SUBJECT: NORTH ANNA UNITS 1 AND 2 - ISSUANCE OF AMENDMENTS RE:
PRESSURE/TEMPERATURE OPERATING LIMITS/LOW TEMPERATURE OVERPRESSURE
PROTECTION SYSTEM PRESSURE SETPOINTS/LIMITING CONDITIONS FOR
OPERATION, ACTION STATEMENTS, AND SURVEILLANCE REQUIREMENTS FOR
PORVs AND BLOCK VALVES TO ADDRESS GENERIC LETTER 90-06 (TAC NOS.
M77363, M77364, M77433, M77434, M89312, AND M89313)

The Commission has issued the enclosed Amendment Nos. 189 and 170 to Facility Operating License Nos. NPF-4 and NPF-7 for the North Anna Power Station, Units No. 1 and No. 2 (NA-1&2). The amendments revise the Technical Specifications (TS) in response to your letter dated April 15, 1994.

The amendments modify the pressure/temperature operating limitations during heatup and cooldown and the Low Temperature Overpressure Protection System pressure setpoints and enabling Conditions for Operation, Action Statements, and Surveillance Requirements for the power-operated relief valves and block valves to address the concerns discussed in NRC Generic Letter 90-06. The proposed changes also include several editorial/administrative changes.

**Figure 3.4-2 — North Anna Unit 1
Reactor Coolant System Heatup Limitations**

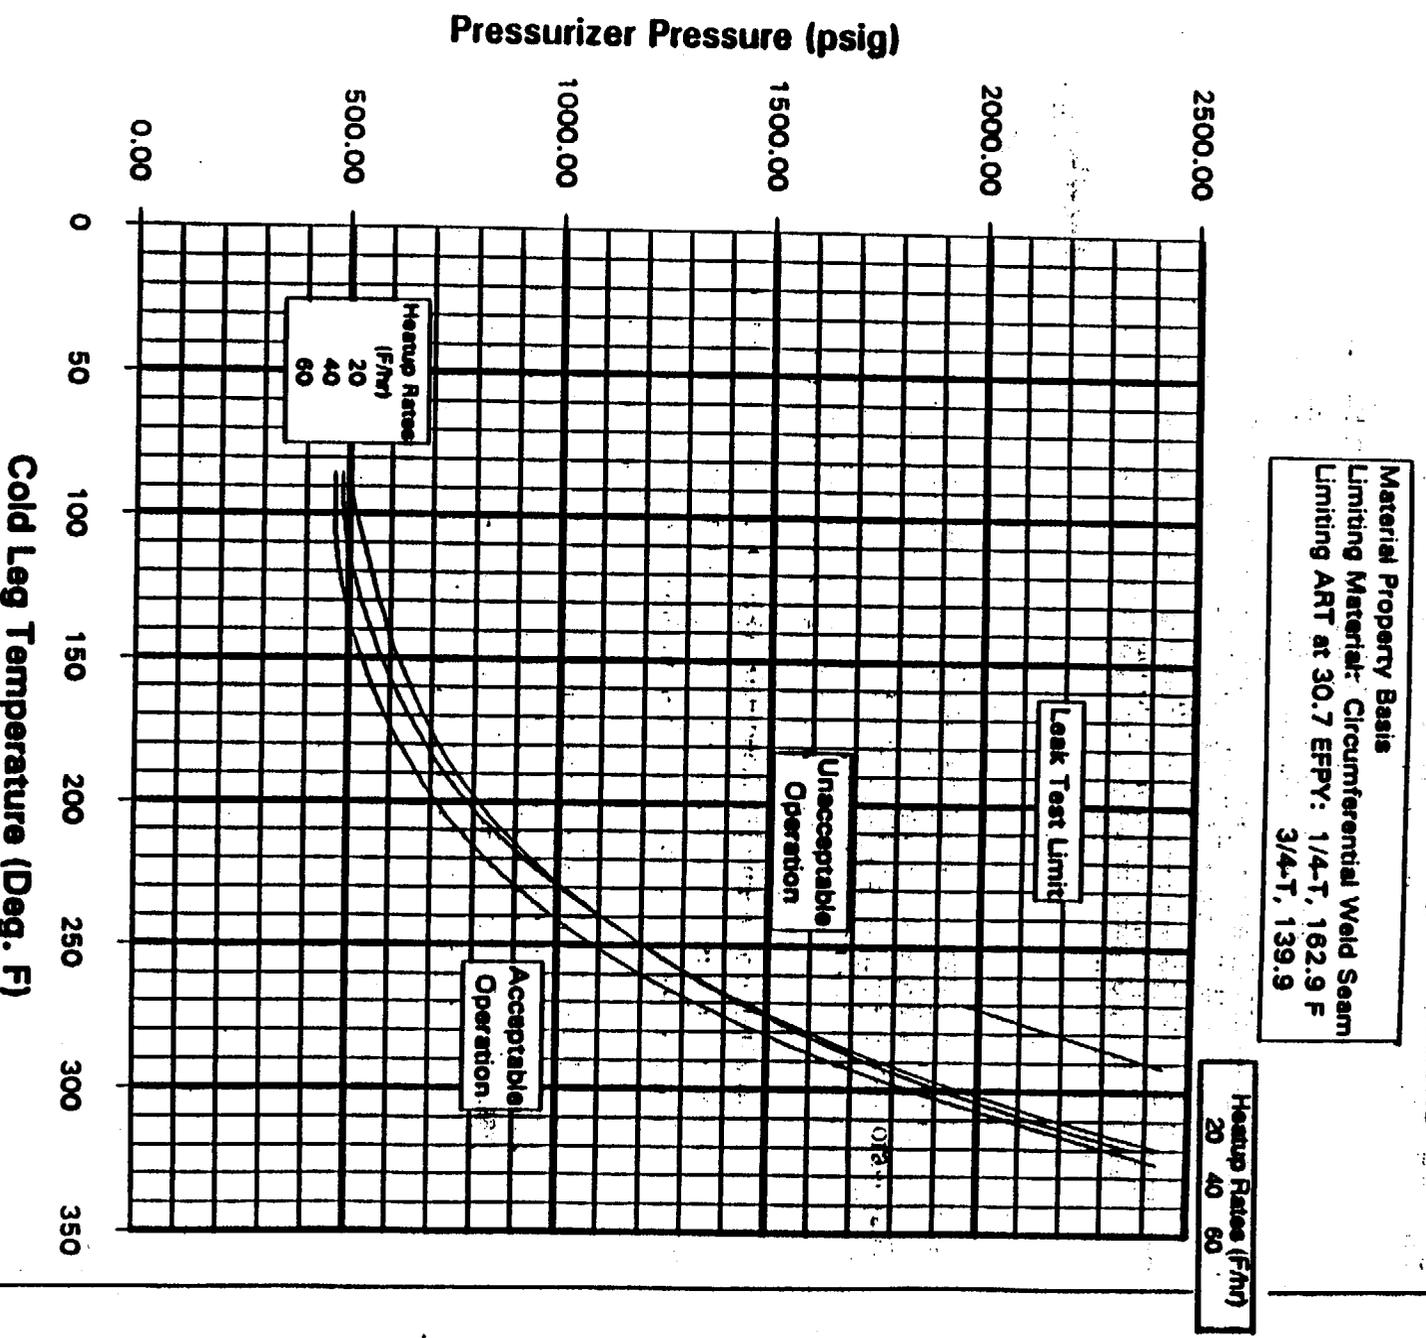
Revised TS Figures NA-1 3.4-2 and 3.4-3 have been prepared to present the revised NA-1, 30.7 EFPY and existing NA-2, 17 EFPY PT operating limit data. The curves have been modified to include a correction for the pressure difference between the point of measurement (i.e., the pressurizer) and the point of interest (i.e., the reactor vessel beltline), but do not include allowances for temperature and pressure measurement uncertainty. The 10 CFR

The NA-1 PT operating limits required by 10 CFR Appendix G have been revised to be valid to 30.7 EFPY (end-of-license) by including the effects of the incremental radiation exposure on the reactor vessel beltline region. The curves are based on analyses of NA-1 reactor vessel materials surveillance capsule results. The revised Appendix G curves were prepared in accordance with approved Westinghouse methodologies and Regulatory Guide 1.99, Revision 2. New NA-2 curves are not proposed at this time.

Material Property Basis
 Limiting Material: Circumferential Weld Seam
 Limiting ART at 30.7 EFPY: 1/4-T, 162.9 F
 3/4-T, 139.9
